DRG. NO. **OS/065**

THE JENNINGS MUSICAL INDUSTRIES LTD.

'VOX' A.C. 30.36 AMPLIFIER CIRCUIT
NORMAL
DRAWING FOR WORKS USE ONLY

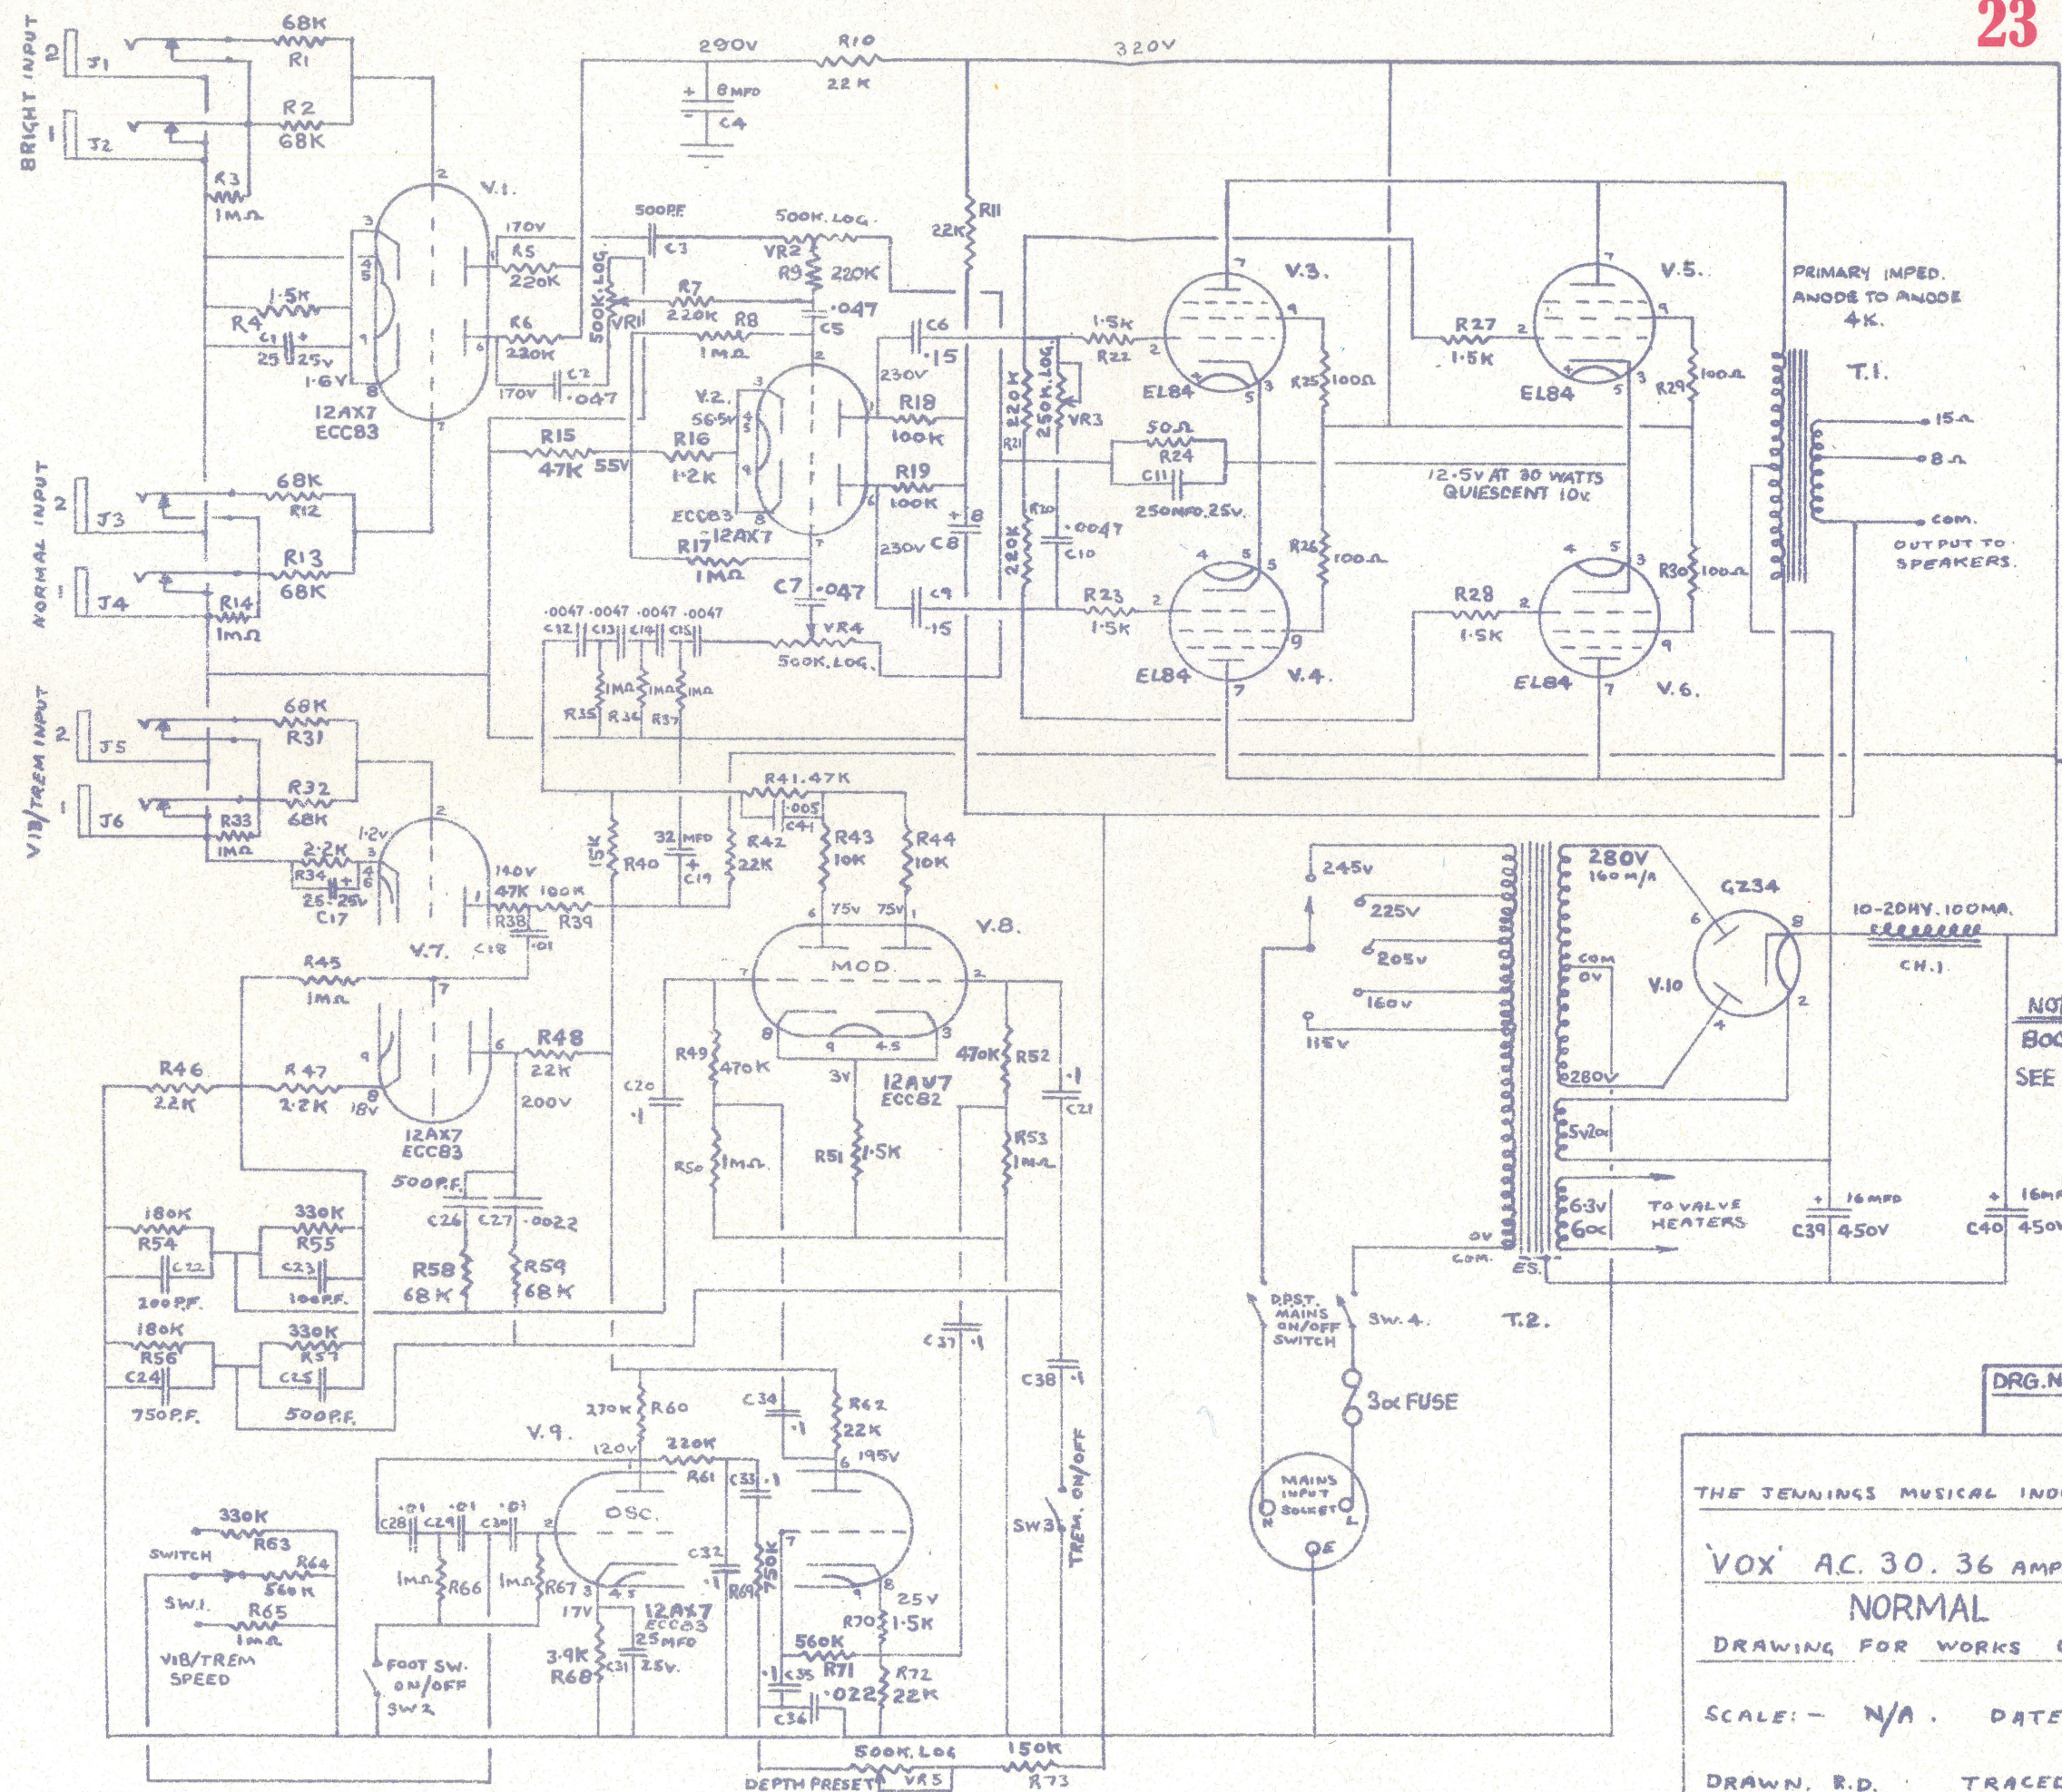
C41 ADDED
7-2-61

R4 WAS 2.2K
R5 " 100K
R6 " 100K
R7 " 270K
R9 " 270K
R38 " 1MΩ
R39 " 150K
R40 " 12K
R65 " 1.5MΩ
R69 " 1MΩ

R74 ADDED
C2 WAS .01MFD
C5 " .01 "
C6 " .01 "
C7 " .01 "
C9 " .01 "

C16 DELETED
C41 WAS .005MFD

K55.2.14.6.63 M.T.
NOTE ADDED.

R74 DELETED
R24 WAS 80Ω
FUSE MOD.
280V WAS 285V

ISS.3.11.10.63 M.T.
TITLE CHANGE
NORMAL ADDED
ISS.4.11.9.64
